CENTRE PIN ISSUE 3 FOR FULL DETAILS D C96037-010 FOR FIT DETAILS		2	GROOVE DIAM NOW 3.2 WAS 4.0 GROOVE WIDTH NOW 0.5 WAS 0.64 CHAMFER NOW 0.3 WAS 0.5 IGES FILE NOW ISSUE 2					21-10-08			
			ISSUE	REVISIONS							
	TITLE	LIMITER INSET CENTRE PIN 12W		MIGHTON		DRAWN	JD	DATE	16-09-08		
		LIMITER INSET CENTRE PIN 12VV	JOB NO.	C96037		CHECKED		DATE			
	MATERIAL	STAINLESS STEEL	VIEW	3rd Angle		APPROVED		DATE			
	COLOUR/FINISH	DUR/FINISH	SCALE DRAWN	AS ABOVE	SHEET		DRG.NO.	C06027 02	024		
			ISSUE	1	OF			C96037-021

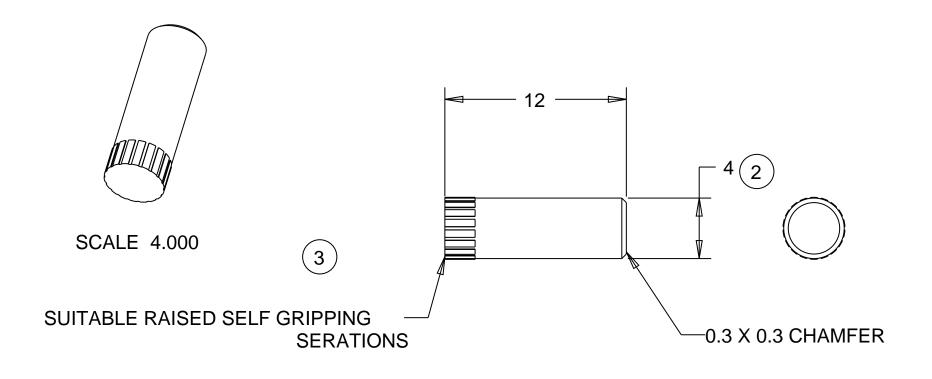
ADDED

CIRCLIP GROOVE REMOVED.

PIN DIAM NOW 4.0 WAS 4.6
